BELOW-THE-HOOK LIFTING DEVICE
Engineering Note Cover Page

Device Name or Description: CDF / COT FLIPPING FIXTURE

To: Win Baker, CDF Upgrade ES&H Review Committee Chair
From: Fritz Lange, CDF Mechanical Safety Subcommittee
Subject: Review of CDF COT Rotating Fixture and Support Stand

Experiment	CDF / COT
Project	COT Flipping Fixture
Author(s)	Rafael Silva (FNAL)
Reviewer(s)	Bob Woods (FNAL)
Abstract	Structural analysis of the COT Flipping Fixture.

F.E.A. of the COT Flipping Fixture - Lifting Assembly

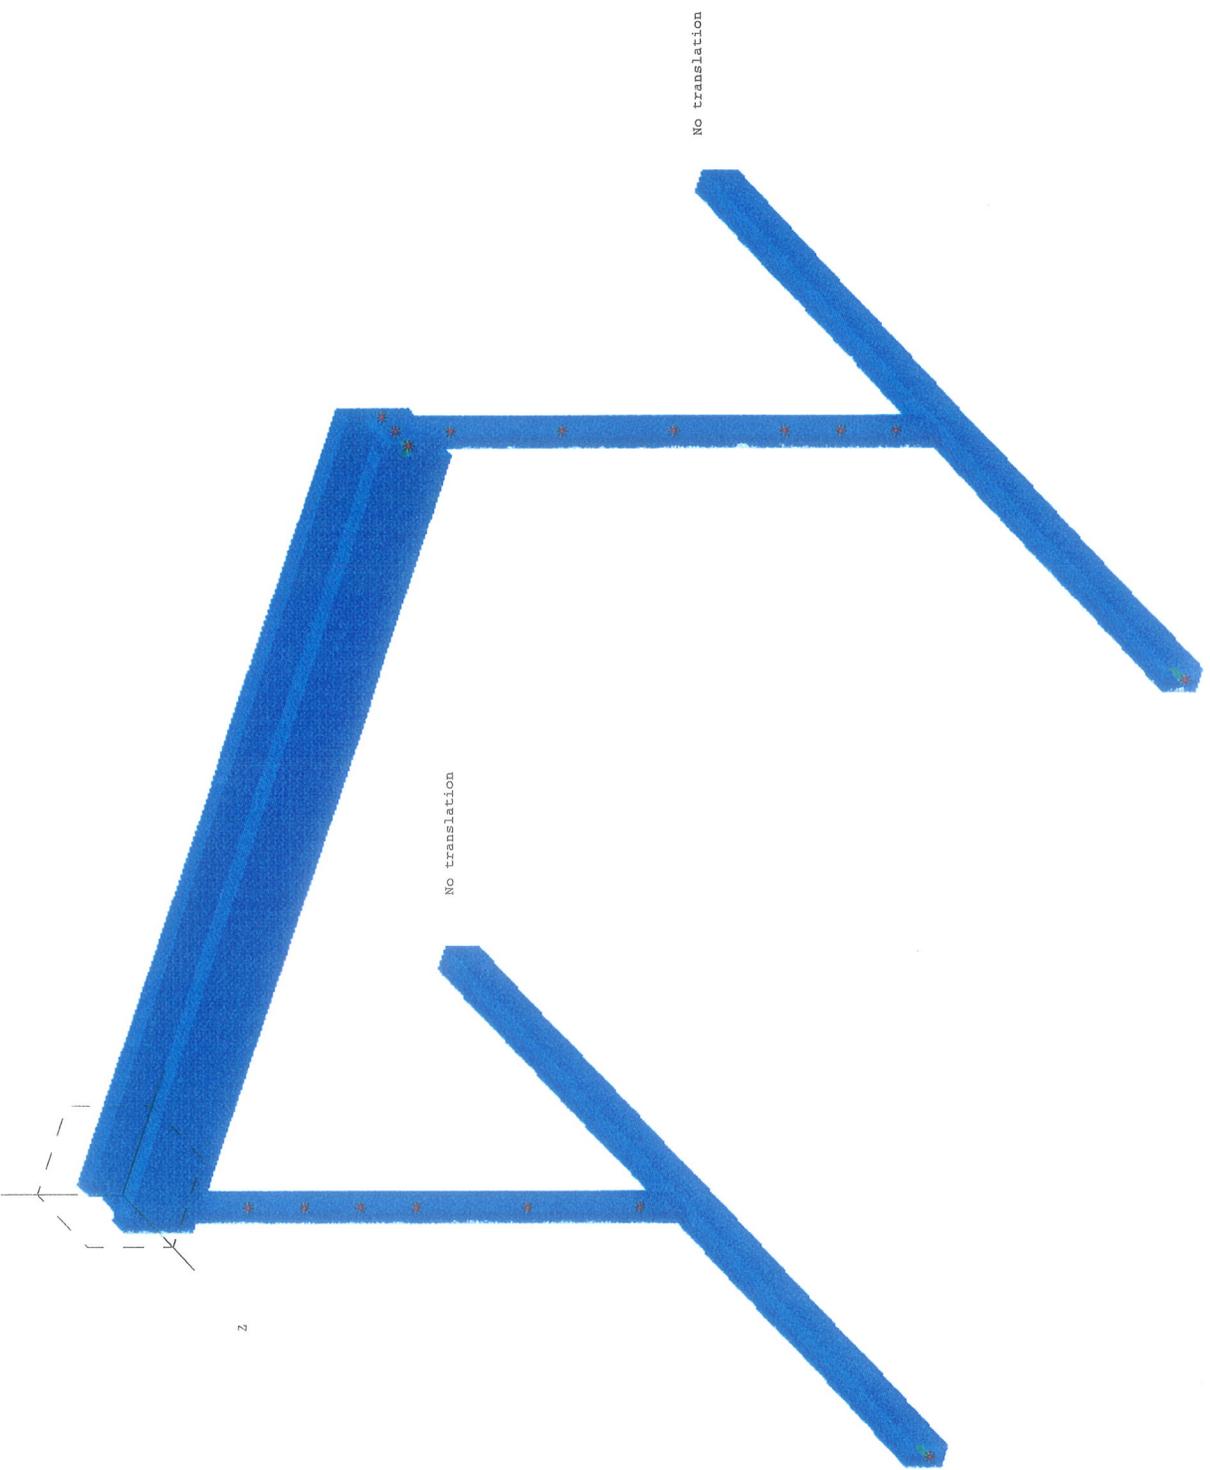
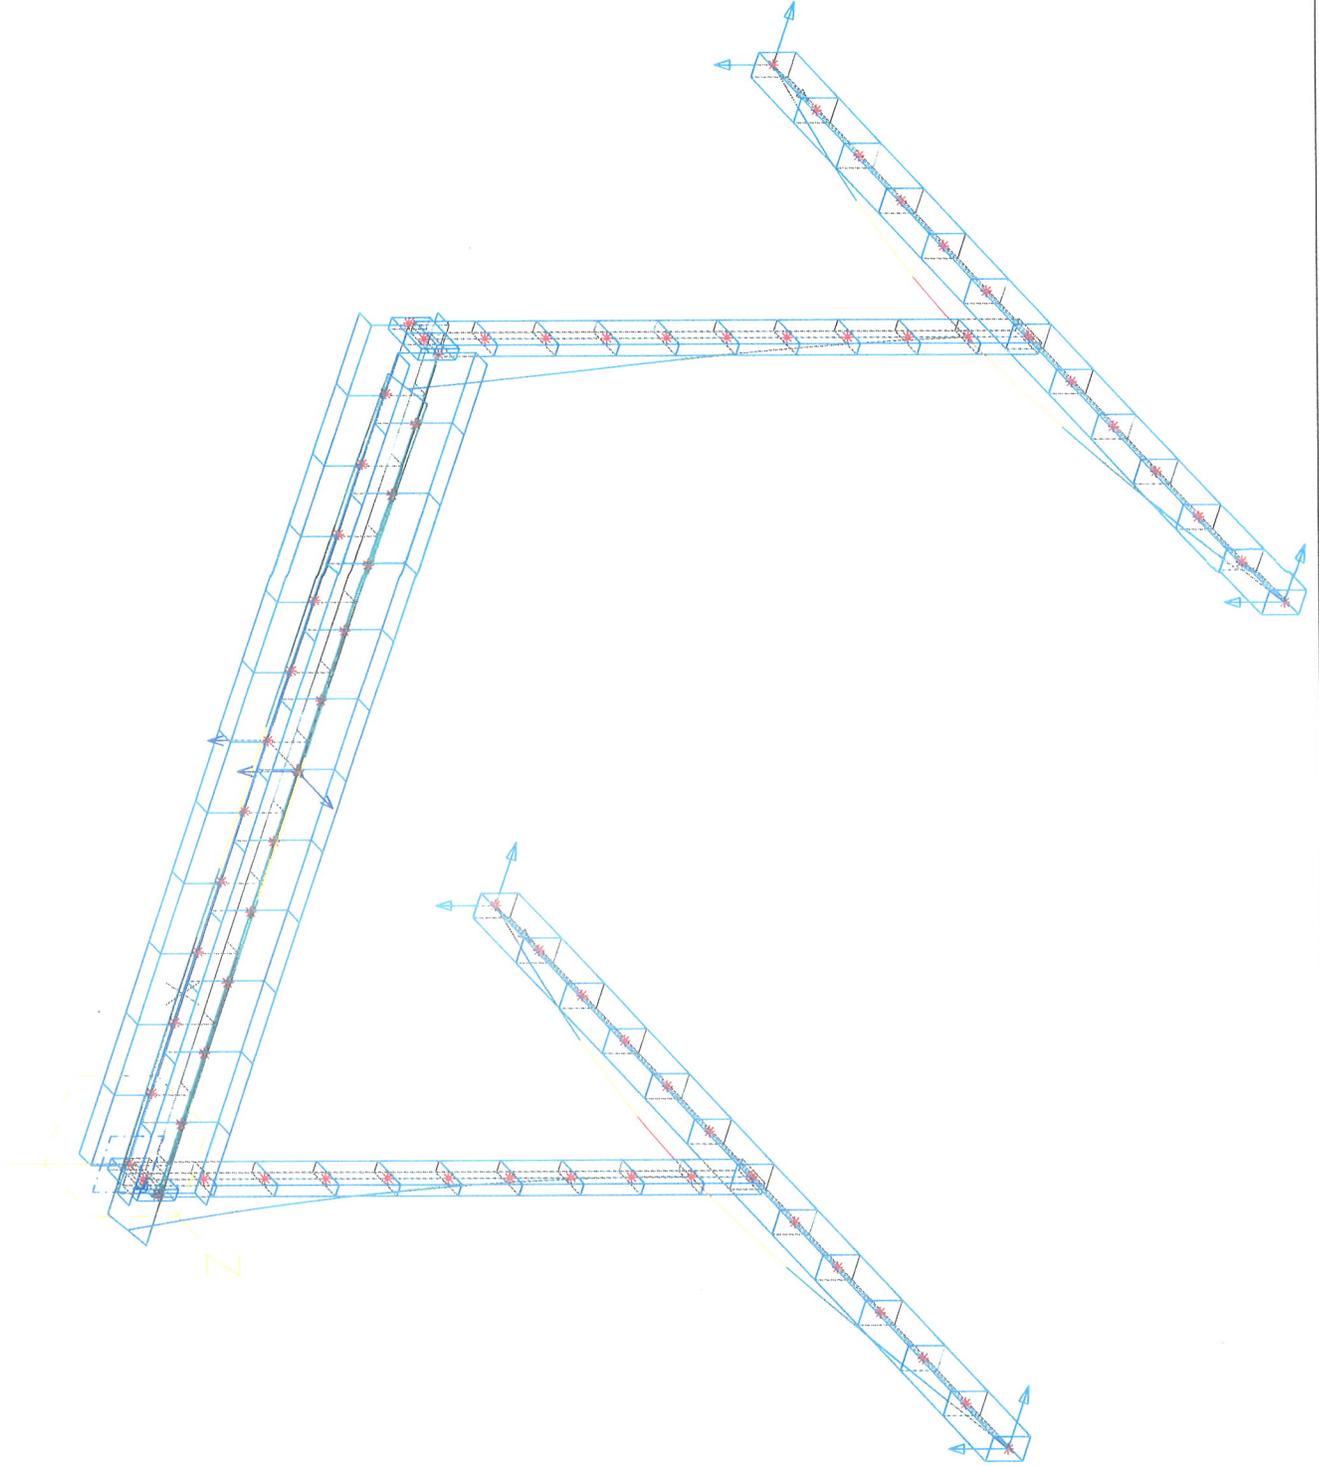
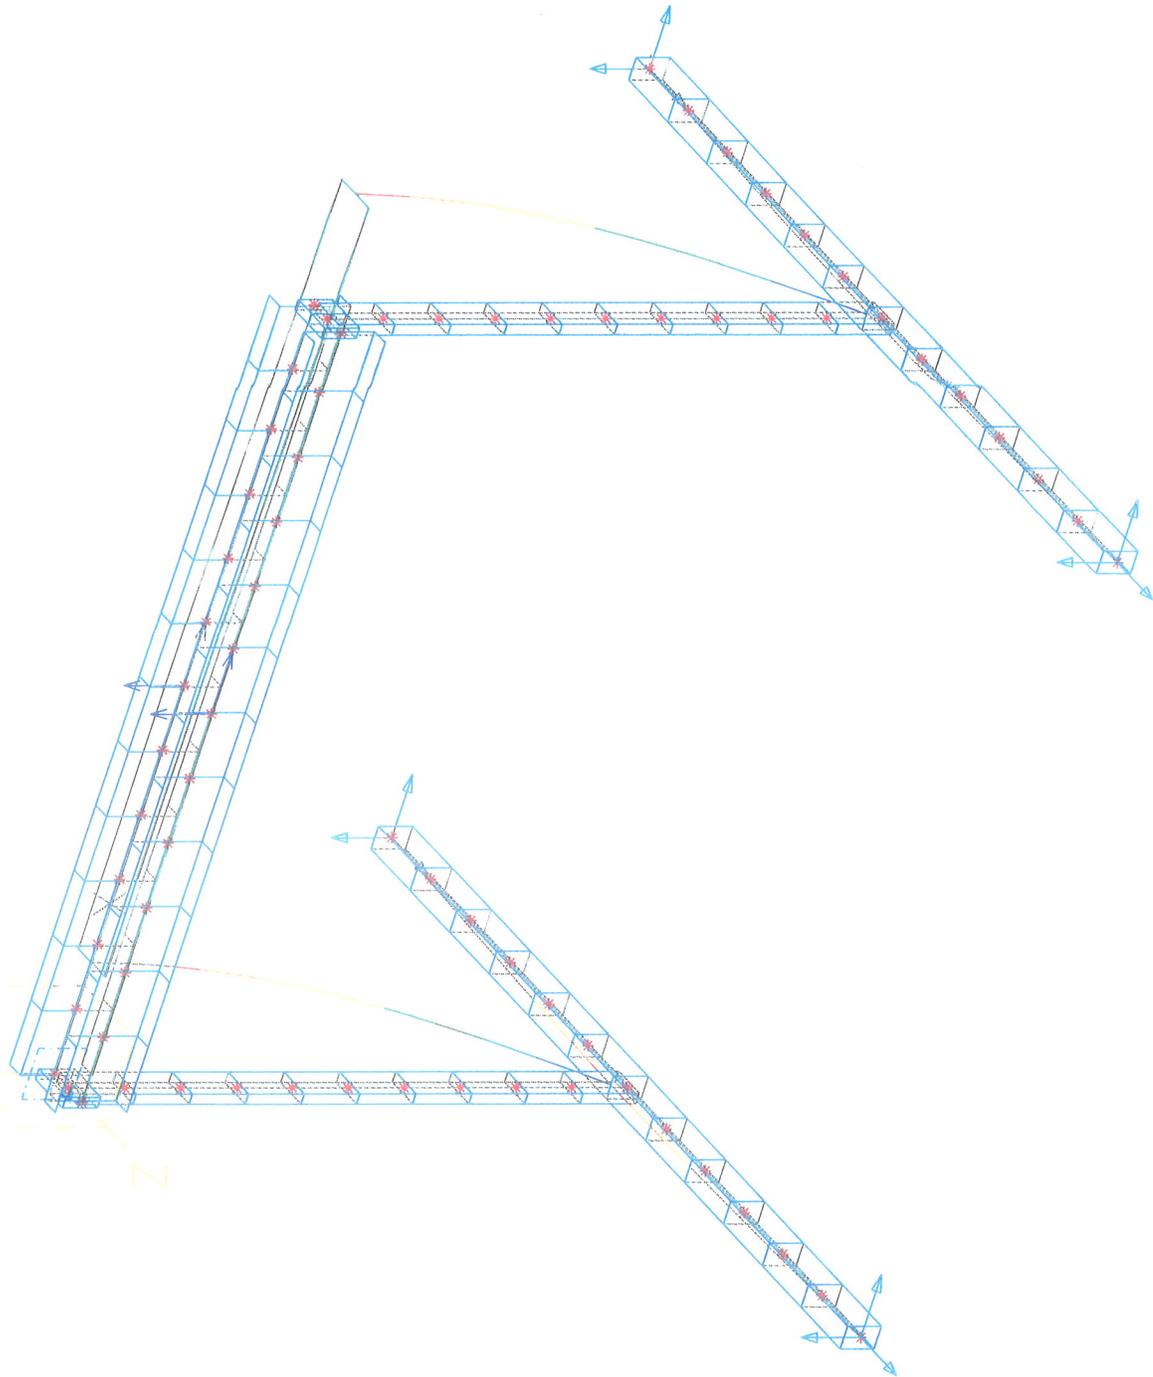
I am curious, what the displacements are for item c. All the FEA plots show stresses with no displacements listed.
